ADDENDUM NO. 3

Date: August 21, 2023

Issued by: Sacramento City Unified School District

Project: **Project #: 0510-465**
0510-465 CKM/Fern Bacon/Matsuyama/Parkway/Rosa Parks and Sutterville
Security Improvements: Group 2

SHEET NO.
C1.0.2

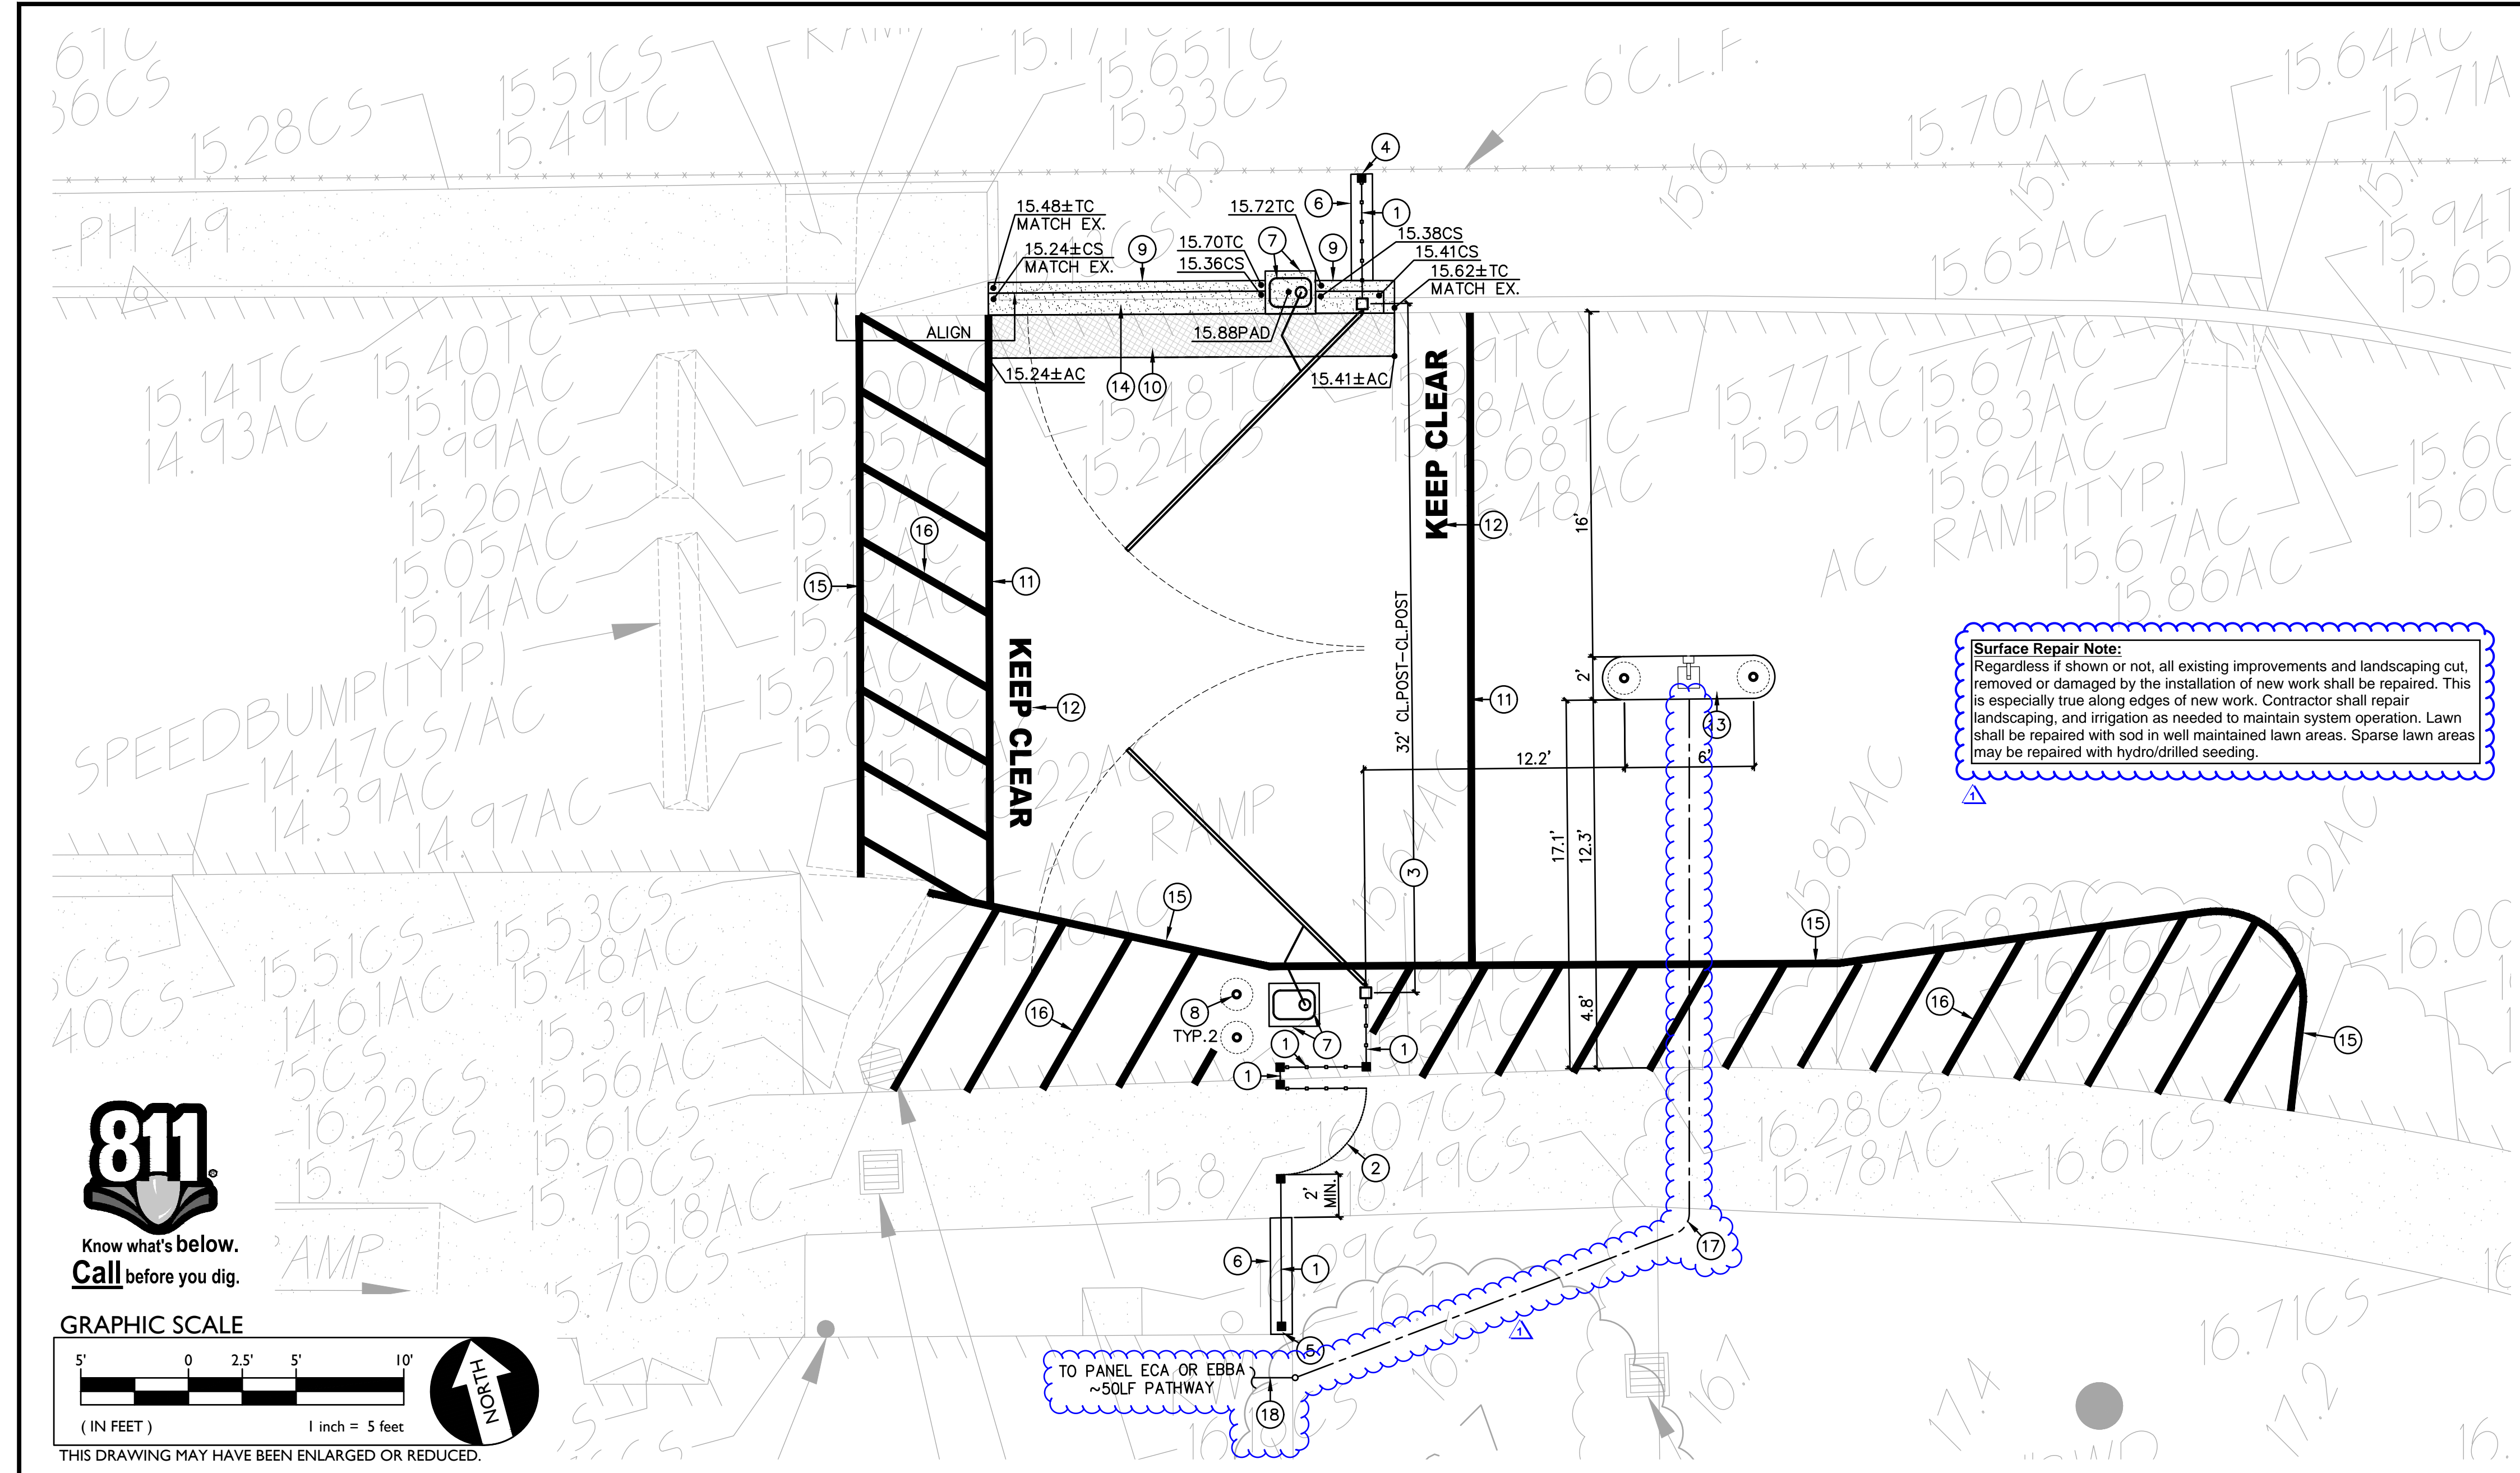
Sheet C1.0.2

- New Site fire access plan provided.

SHEET NO.
C1.1

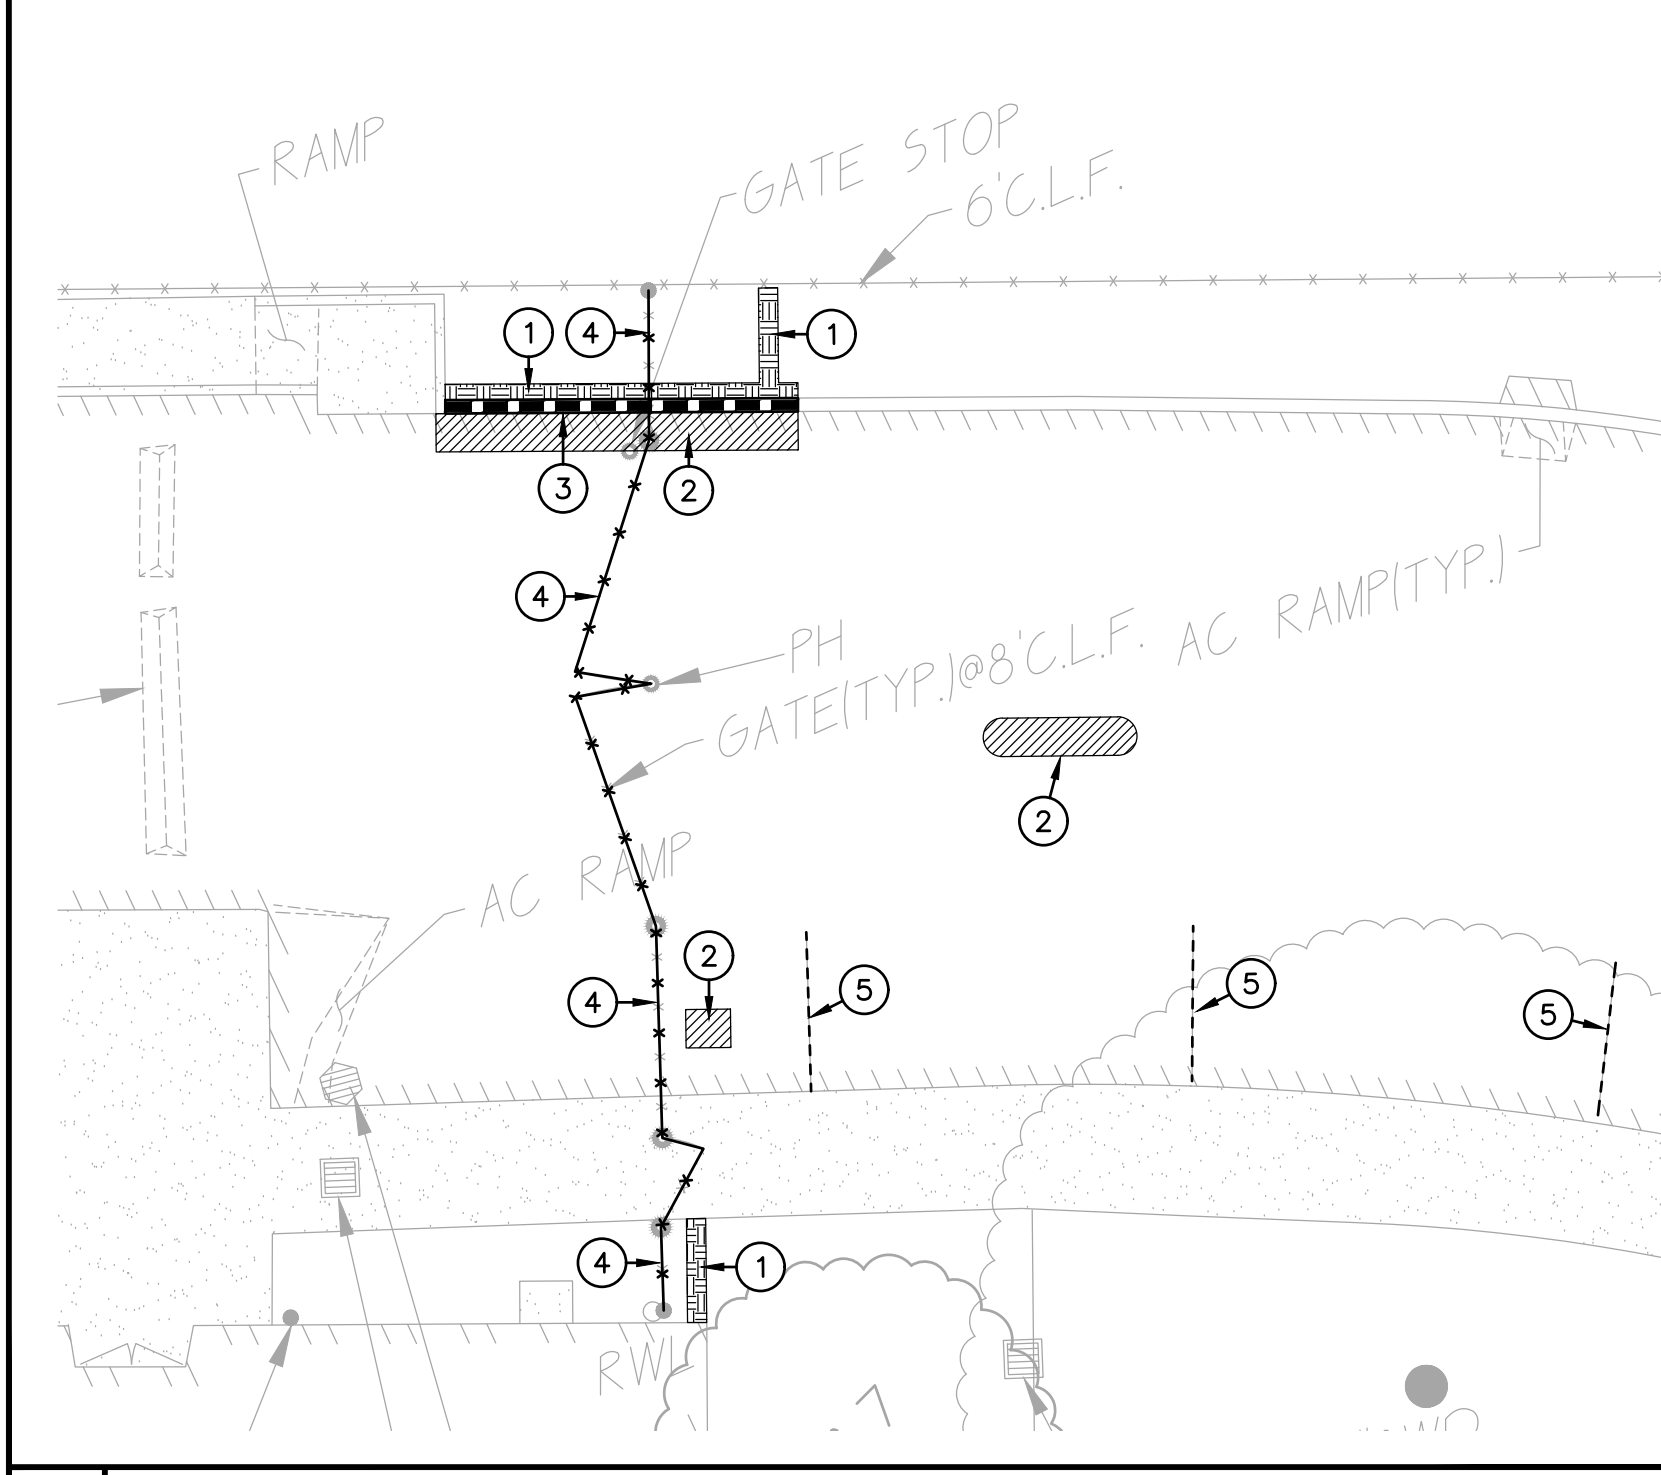
QUESTION #2: It appears that the power for the gate operators at McClatchy was not included in the drawings.

Sheet C1.1

- Surface repair general note added.
- Note 17 and 18 added and plan adjusted to show conduit and connections for gate opener power supply.

RESPONSE: See attached **AD3.01 – C.K. McClatchy – Addendum No.1 Drawings** for revisions.

SITE ACCESS PLAN

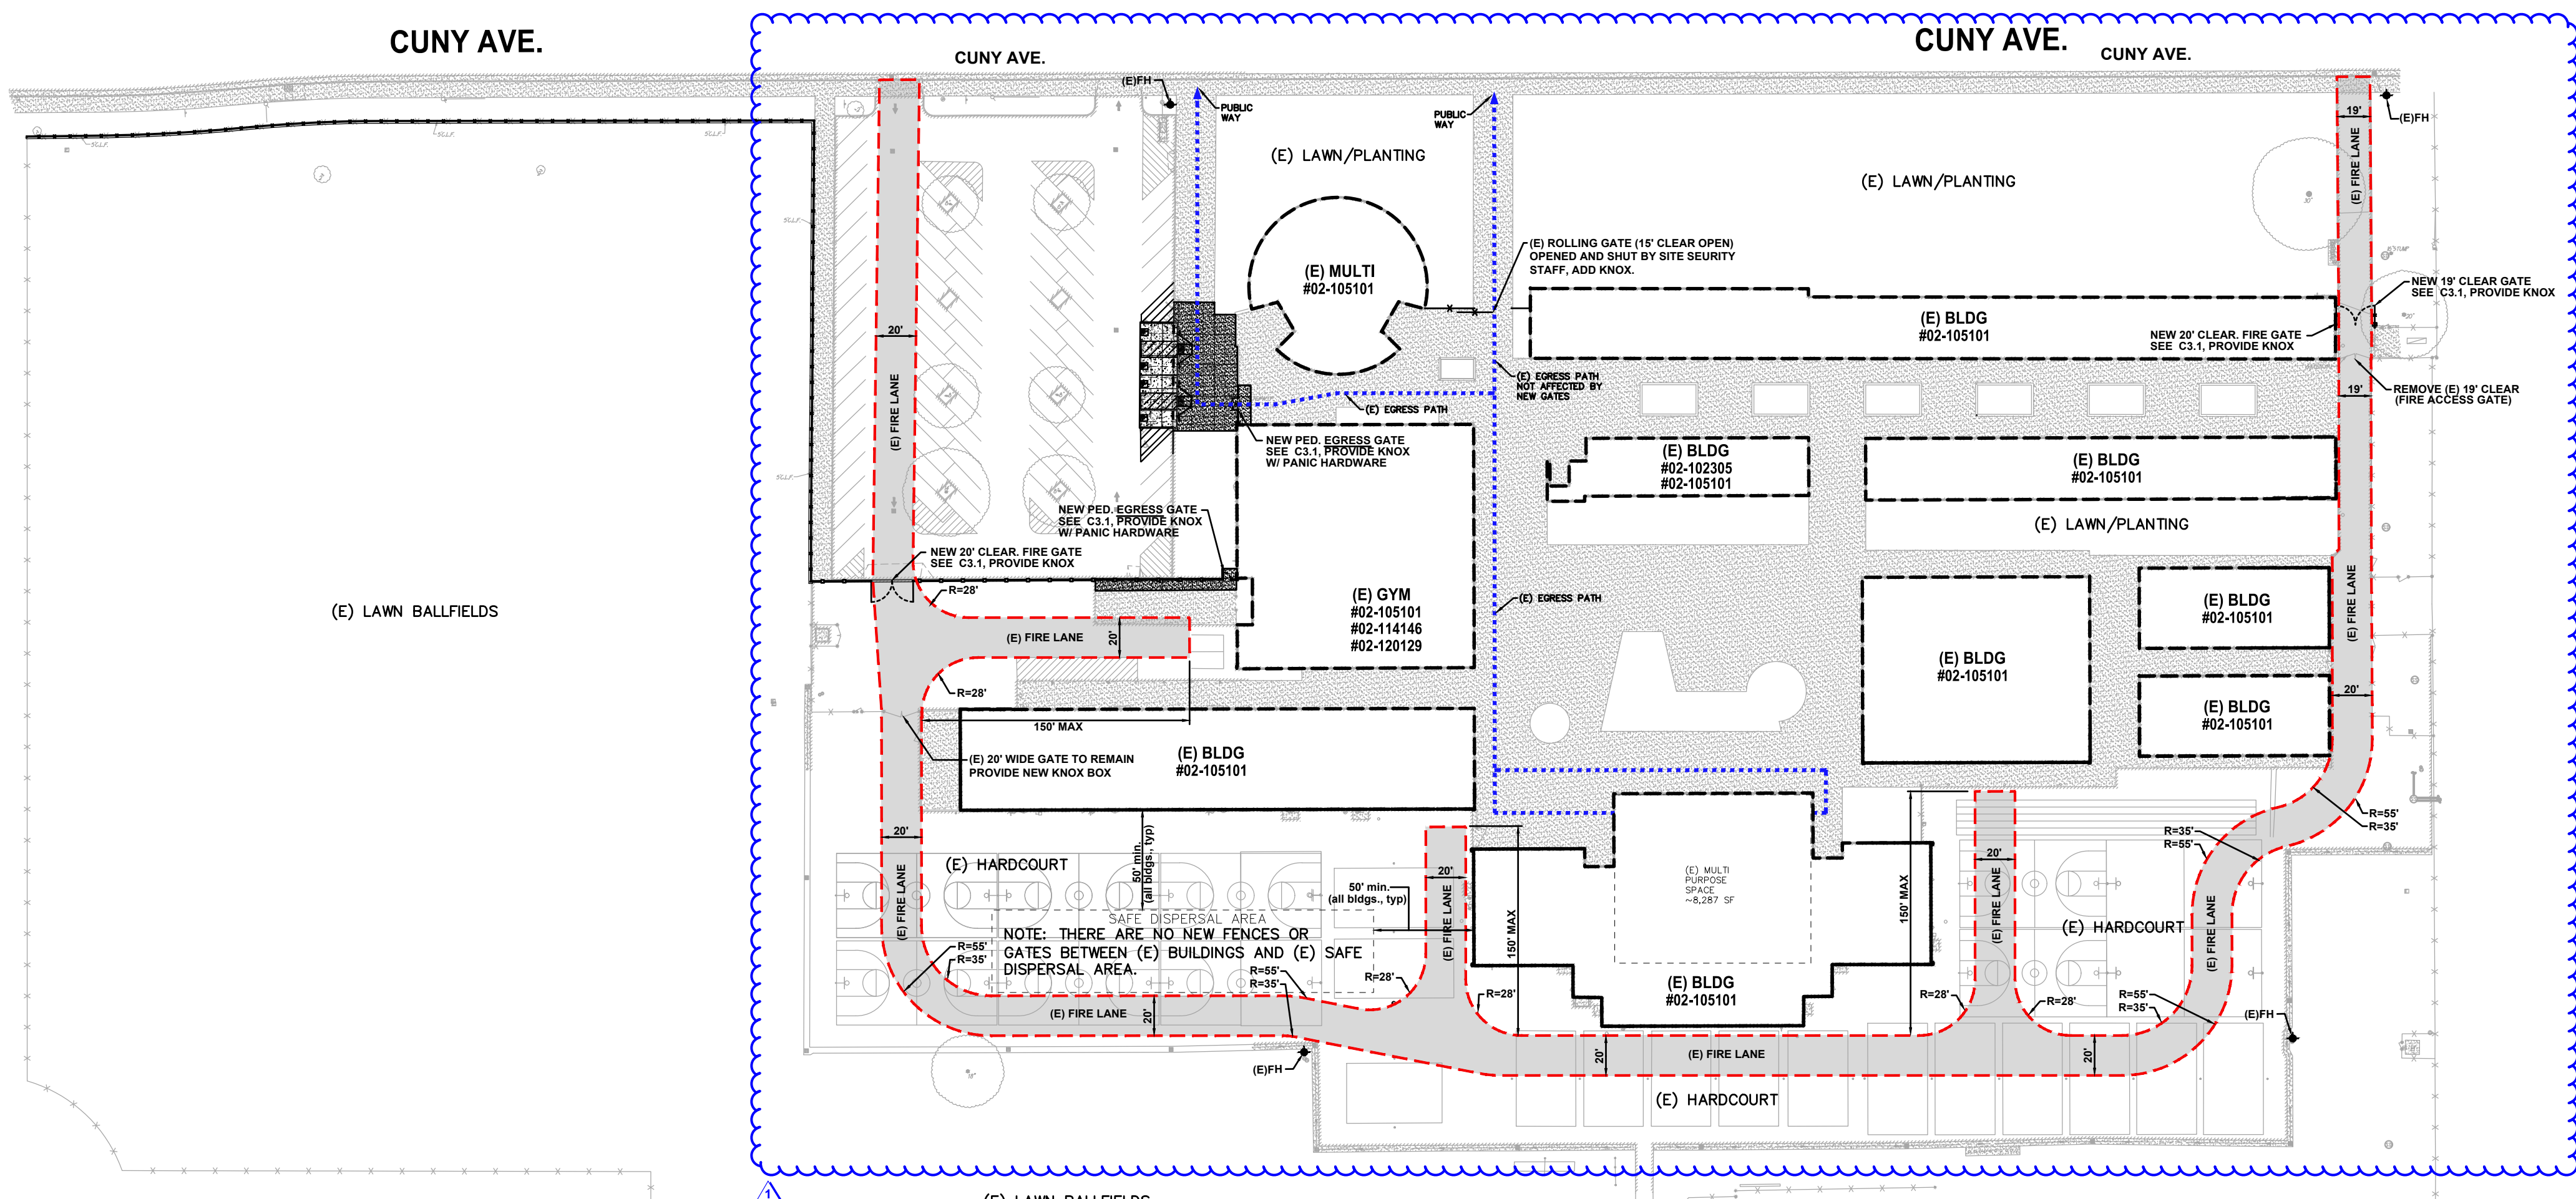
Sheet C1.0.1

- Site access plan updated with additional references.
- Gate legend added.
- General access notes added.
- Typical gate clearance details added.
